SUBJECT: Statement of Basis/Proposed Plan for the Early Construction and Operational Disposal Site N-1 (NBN), Central Shops Scrap Lumber Pile (631-2G), and Building 690-N, Process Heat Exchanger Repair Facility (aka Ford Building) Operable Unit (U) (SRNS-RP-2022-00202, Revision 1 Redline, December 2022) and Savannah River Site's Responses to the Regulatory Comments on the Revision 0 Document, SEMS Number: 93

**SRS Responses to South Carolina Department of Environmental Health and Control
Comments on the Statement of Basis/Proposed Plan for the Early Construction and
Operational Disposal Site N-1 (NBN), Central Shops Scrap Lumber Pile (631-2G), and
Building 690-N, Process Heat Exchanger Repair Facility (aka Ford Building) Operable
Unit (U), SRNS-RP-2022-00202, Revision 0, July 2022, SEMS Number: 93
Savannah River Site, South Carolina**

**SRS Responses to U.S. Environmental Protection Agency
Comments on the Statement of Basis/Proposed Plan for the Early Construction and
Operational Disposal Site N-1 (NBN), Central Shops Scrap Lumber Pile (631-2G), and
Building 690-N, Process Heat Exchanger Repair Facility (aka Ford Building) Operable
Unit (U), SRNS-RP-2022-00202, Revision 0, July 2

Figure 5. Ford Building Subunit 2019 Sample Locations

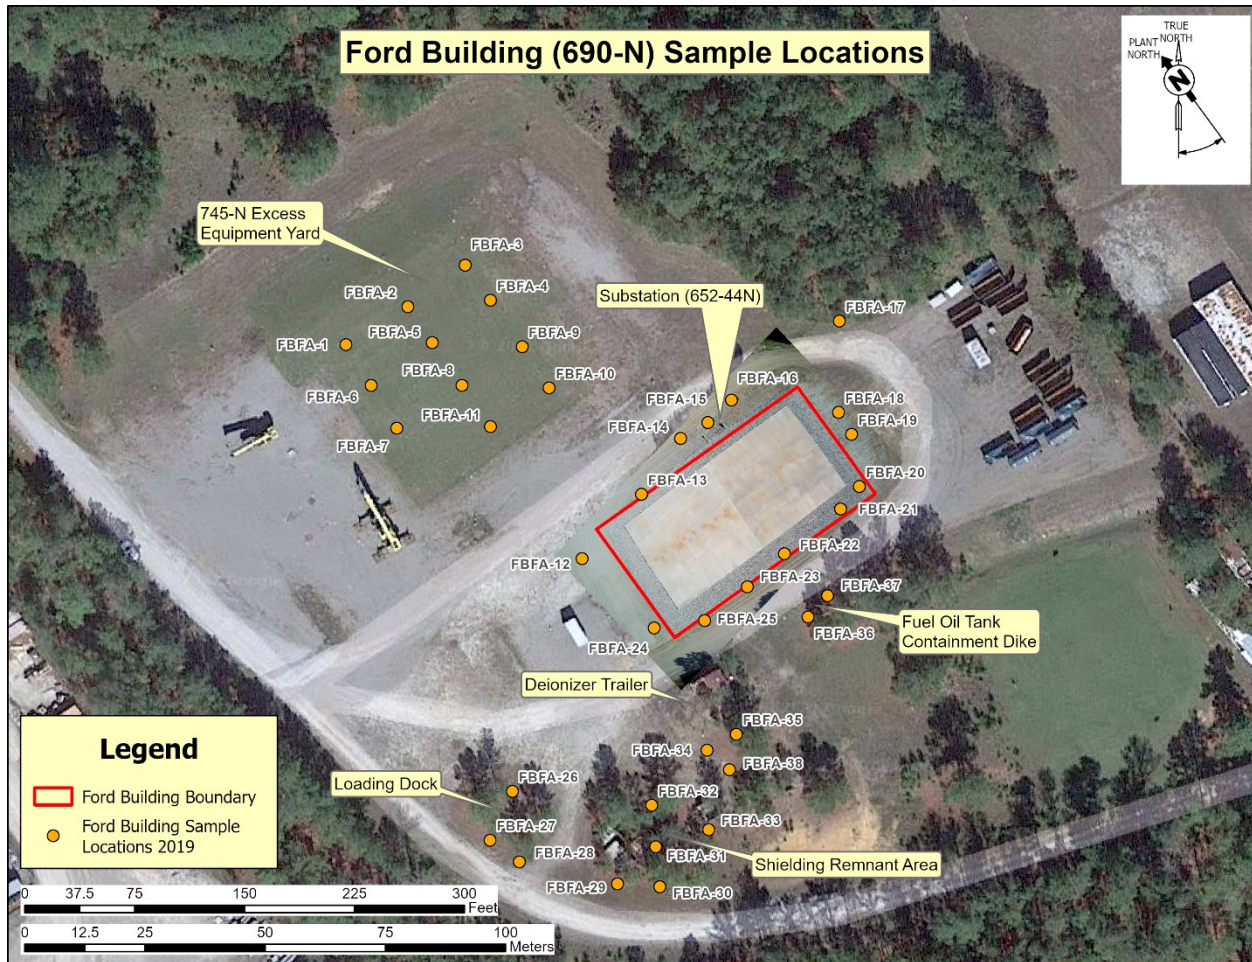
- c. **Building 690-N, Process Heat Exchanger Repair Facility (Ford Building) Subunit:** Soil and concrete sampling is discussed for the Ford Building; however, it is unclear if the constituents of concern (COCs) on the concrete slab and in site soil have been delineated. For example, Figure 7 (Ford Building Subunit Cobalt-60 Data [0-1 ft]) indicates that the only sample collected on the south side of the former building detected cobalt-60, but the lateral and vertical extent of this contamination is unclear. Further, none of the figures show the locations of the concrete samples.

The SB/PP should discuss and show on site figures the lateral and vertical extent of contaminated media to support the discussion of alternatives and selection of the preferred remedies. *Revise the SB/PP to include a description of the extent of the contaminated areas in each subunit.*

- c) Figures that identify the locations of the concrete and soil samples are provided in the Human Health Risk Screening Evaluation for 690-N Ford Building (SDD-2019-00030, Revision 0, April 2019), referenced within the SB/PP. It should be noted that the SB/PP, Section VI, Remedial Action Objections, states the concrete cover that now exists over the Ford Building remnant slab eliminates any exposure to the contamination that exists on the slab.

Cobalt-60 was identified as a COC at the Ford Building subunit due to SRS selectively speciating the ten highest non-volatile beta results, even though none of the original samples exceeded the 50 pCi/g non-volatile beta screening threshold for soils. During this speciation, cobalt-60 was identified as exceeding the 1E-06 risk level for resident and industrial worker scenarios at only one location (FBFA-21) identified on Figure 7 of the SB/PP. The other locations were below the detection limit. The three closest soil locations to FBFA-21 were not speciated, as they were not among the highest non-volatile beta results. SRS proposed additional sampling for the soils surrounding the Ford Building if radiological surveys detected any additional contamination after the demolition of the building. As indicated in the RFI/RI/BRA/CMS/FS
